Troy Schools District

**RFP #2324-22
BP#3B Smith Middle School - ARCH & MEP & Civil -
Addendum #2
July 15th, 2024**

Troy Schools District – BP#3B Smith Middle School – ARCH & MEP & Civil – Addendum #2

Addendum #2 Bidder Clarifications

PROJECT NO.
22102
DRAWING NO.
C-6.0

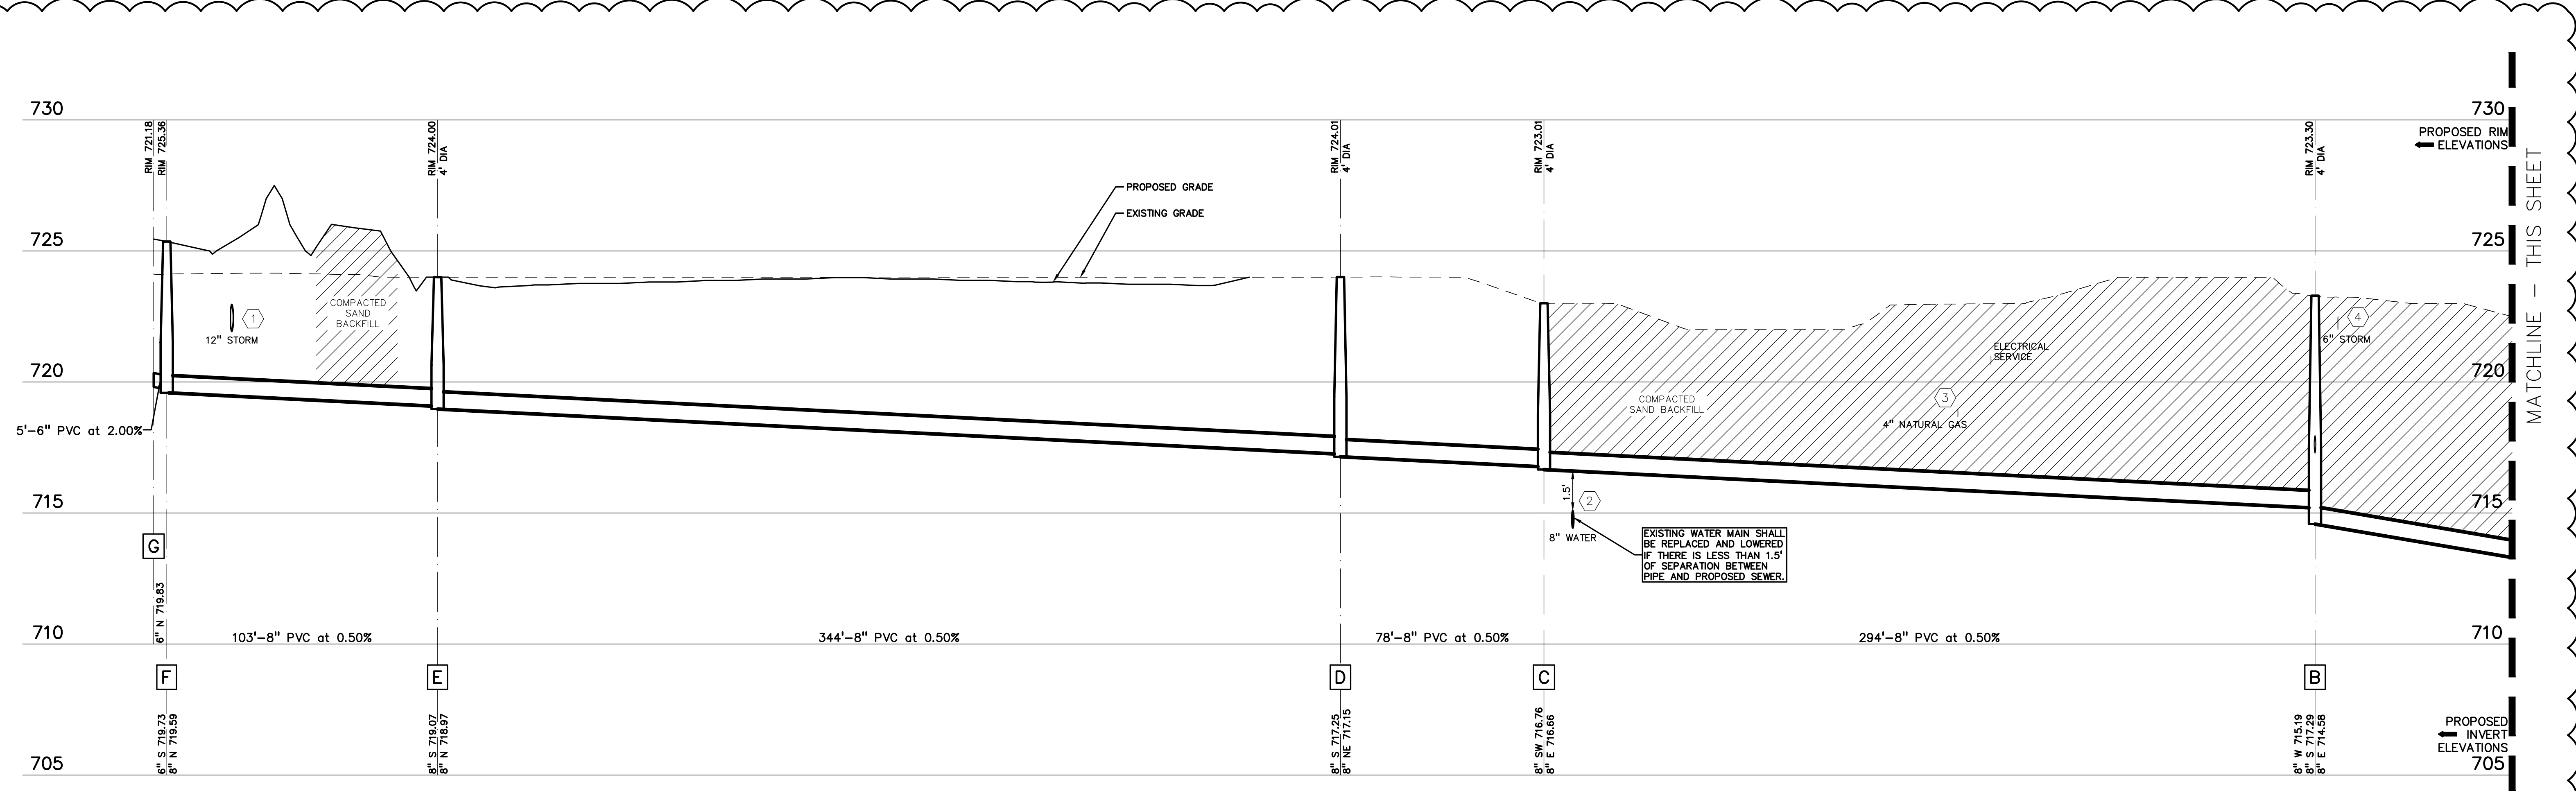
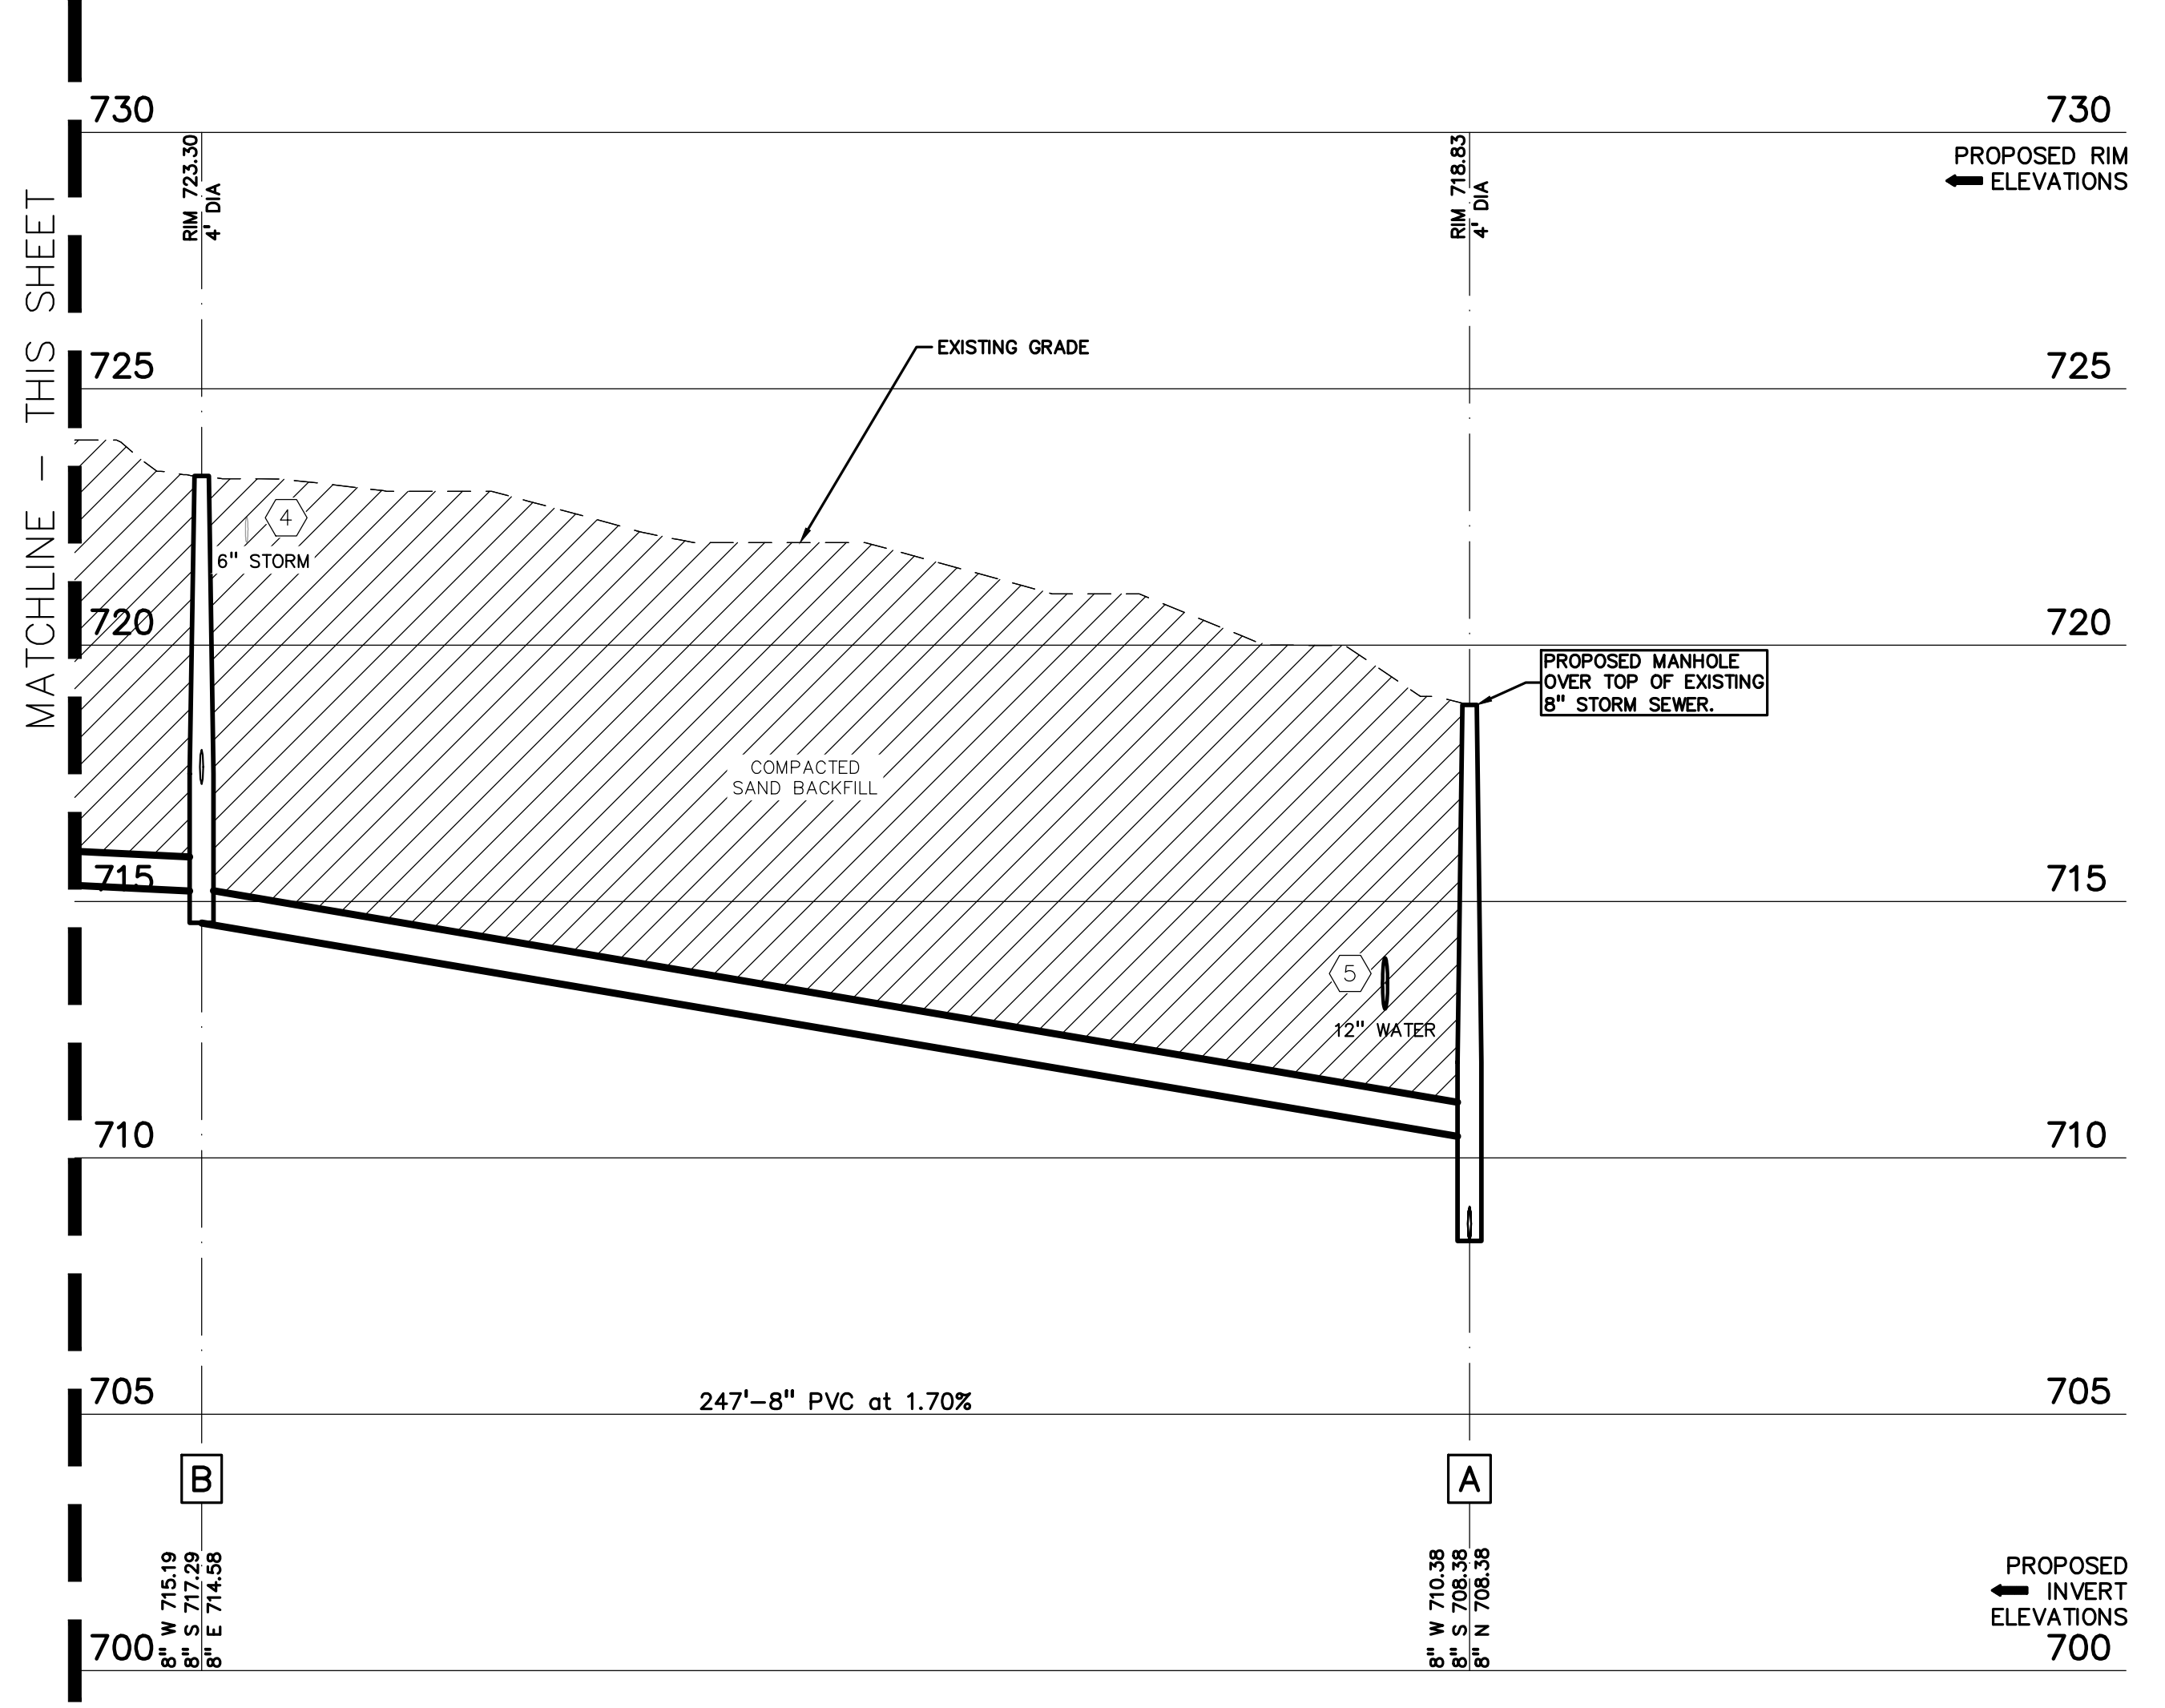
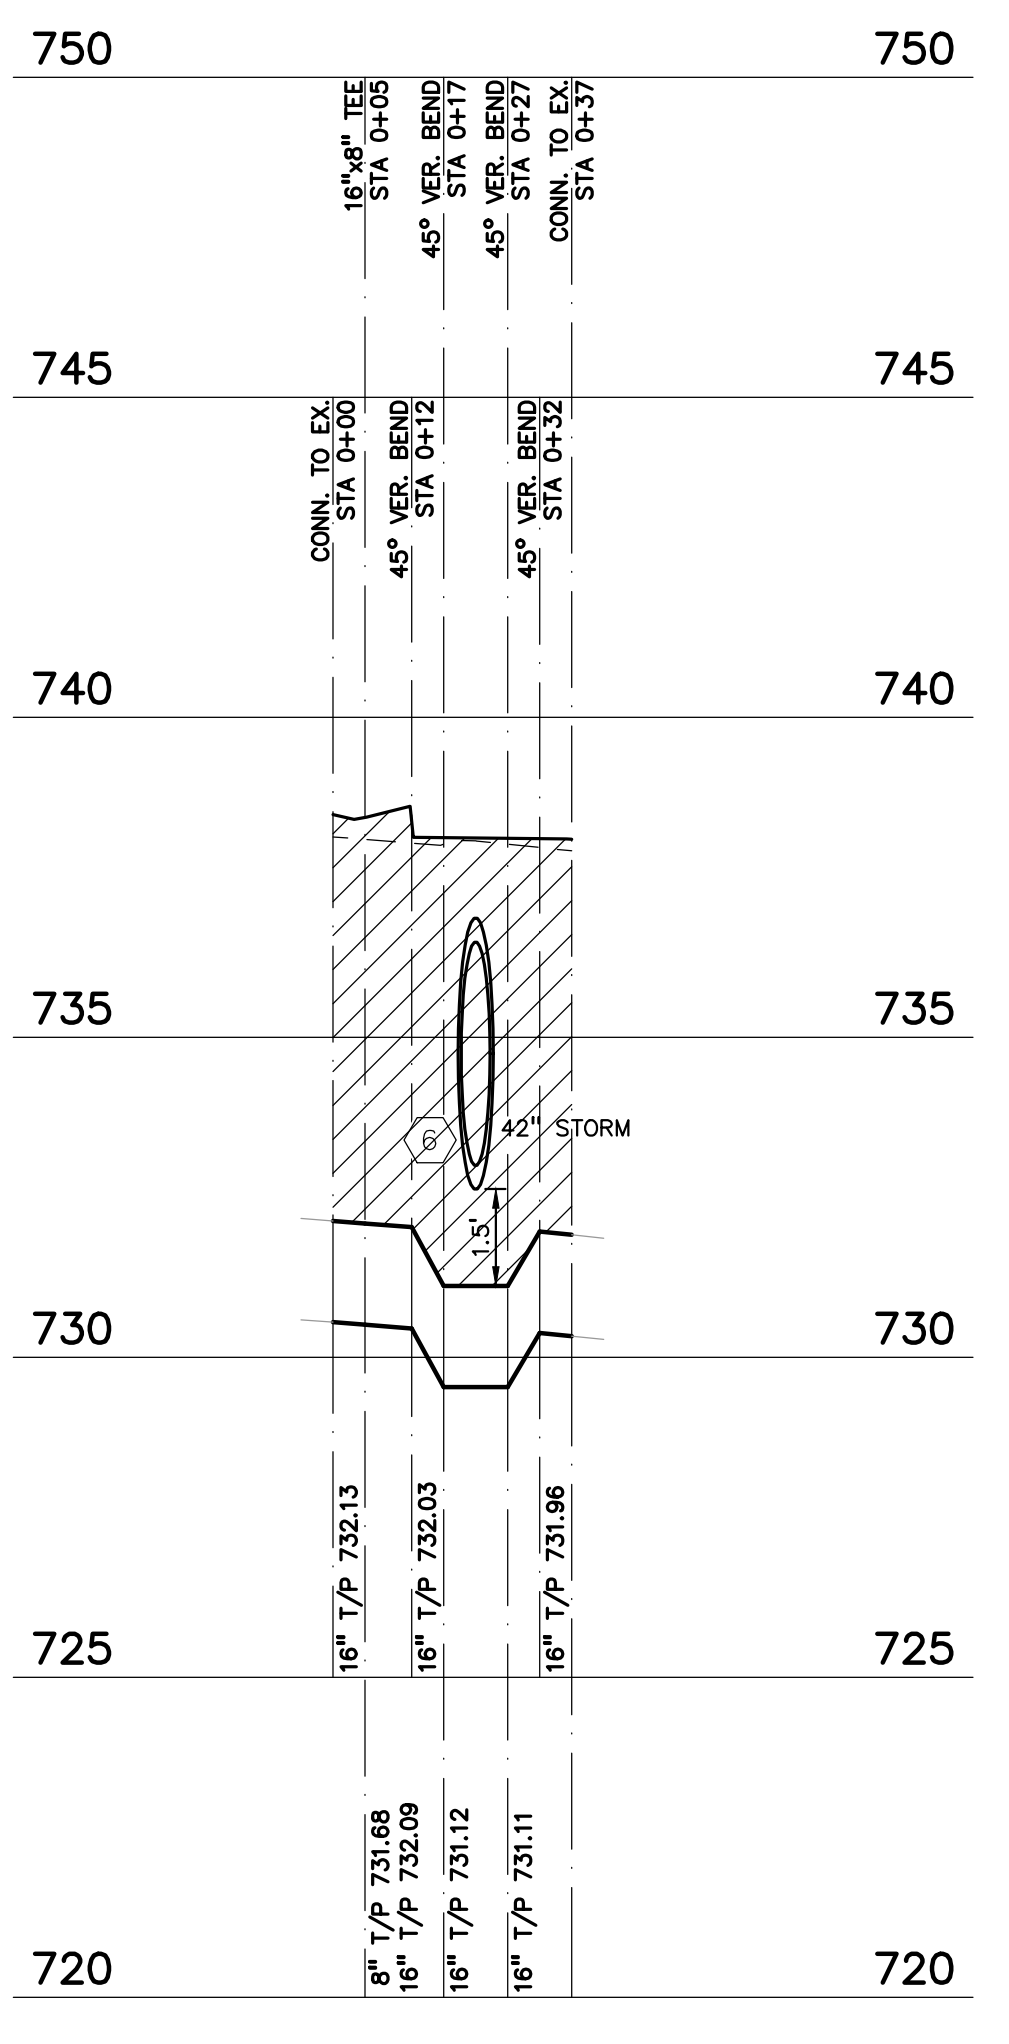
- A. Revised sheet title to include water main.
 - B. Revised sanitary sewer profile as indicated.
 - C. Added water main profile as indicated.
- CD-13 Refer to Drawing No. C-6.1 – Storm Sewer Profiles, C-6.2 – Storm Sewer Profiles, and C-6.4 – Storm Sewer Profiles (reissued):
